ORIGINATION FORM

Proposed Revisions to a Standard Plans Index
(Please provide all information — Incomplete forms will be returned)

Index Number: 455-112

Index Title: 12" CFRP & SS Prestressed Concrete Piles

STRAND PATTERN

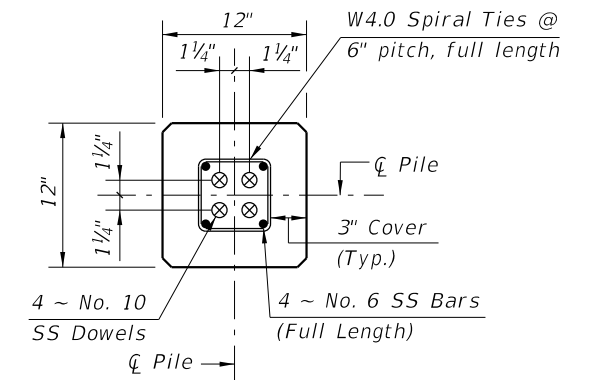
Added 0.6" HSSS strand

8~0.6" Ø HSSS at 26 kips

STRAND PATTERN

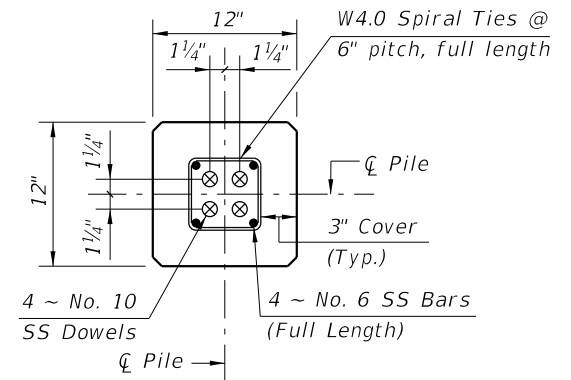
- 8 ~ 1/2" Ø, HSSS at 24 kips
- 8 ~ 0.6" Ø, HSSS at 26 kips
